Access Compliance Report

Public Rights-of-Way

(Curb Ramps)

Intersection ID: 12405	Main Street: ENDOLWOOD_RD	Cross Street: KIMMERLY_GLEN_LN	Location: NE
ADA ID: 93783010C549	Ramp Type: Perp	Initial Pass/Fail: Fail	Overall Compliance: No
Severity Score: 46.25			
Codes/Mitigation Info/Possible Solution		Field Measurements/Component Compliance

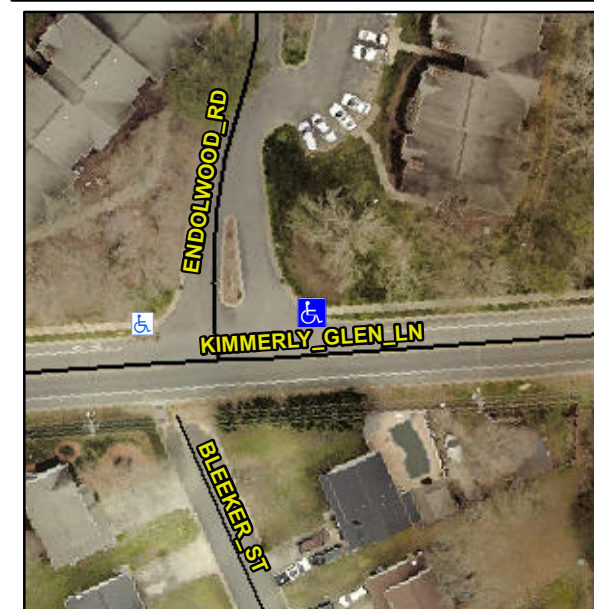
R304.5.1, R304.2.2, R304.5.3

Compliance	Description	Data	Compliance	Description	Data
N/A	Ramp Length (in)	26.0	No	Ramp Slope (%)	10.3
No	Ramp Width (in)	40.0	No	Ramp XSlope (%)	8.2
N/A	Flare Type LT	N/A	N/A	Flare Type RT	N/A
N/A	Flare Slope LT (%)	N/A	N/A	Flare Slope RT (%)	N/A
N/A	Flare Traversable LT?	N/A	N/A	Flare Traversable RT?	N/A
N/A	Landing Length (in)	N/A	N/A	DWS Provided?	N/A
N/A	Landing Width (in)	N/A	N/A	DWS Contrast?	N/A
N/A	Landing Slope (%)	N/A	N/A	DWS Length (in)	N/A
N/A	Landing X Slope (%)	N/A	N/A	DWS Full Width?	N/A
N/A	Landing Curb? (Y/N)	N/A	N/A	DWS Offset (in)	N/A
N/A	Shared Landing?	N/A			
N/A	Gutter Ponding?	N/A	N/A	Gutter Slope (%)	N/A
N/A	Gutter Lip Ht (in)	N/A	N/A	Gutter X Slope (%)	N/A
N/A	Painted X Walk1?	No	N/A	Painted X Walk2?	N/A
	X Walk 1 Direction	To W		X Walk 2 Direction	N/A
N/A	X Walk 1 Width (in)	N/A	N/A	X Walk 2 Width (in)	N/A
	X Walk 1 Slope (%)	1.0		X Walk 2 Slope (%)	N/A
	X Walk 1 X Slope (%)	5.0		X Walk 2 X Slope (%)	N/A

Remove & Replace Entire Ramp.
